ADDENDUM NO. 1

DATE: October 2, 2024

PROJECT: Lift Station No. 3 Forcemain Replacement
Village of Harrison, Calumet County Wisconsin
M&E Project No. 1-0038-063

C1.0

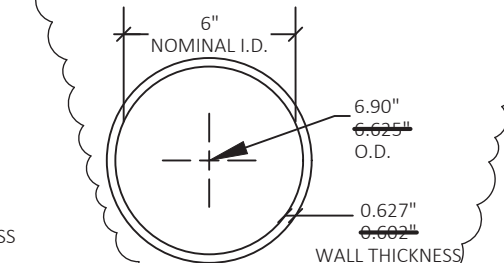
2. Specifications Section 8 – Horizontal Directional Boring Item 2.2A, Polyethylene Piping shall read:
 - A. High density polyethylene (HDPE) piping shall meet the requirements of AWWA C906-15, with DIPS (DIOD) sizing per ASTM D3035, DR 11, Pressure Class 200. Provide compatible fittings.
3. Plan Sheet C1.0

Plan Sheet C1.0 has been revised to show the DIPS (Ductile Iron Pipe Sizing) for the HDPE pipe to be directional bored.

MANUFACTURE: JM EAGLE
 INSIDE DIAMETER: 6.00 INCHES (NOMINAL)
 OUTSIDE DIAMETER: 6.625 INCHES 6.90
 WALL THICKNESS: 0.602 INCHES 0.627
 PIPE MATERIAL: HDPE (HIGH DENSITY POLYETHYLENE)
 PRESSURE RATING: DR: 11.0, DIPS
 200 PSI
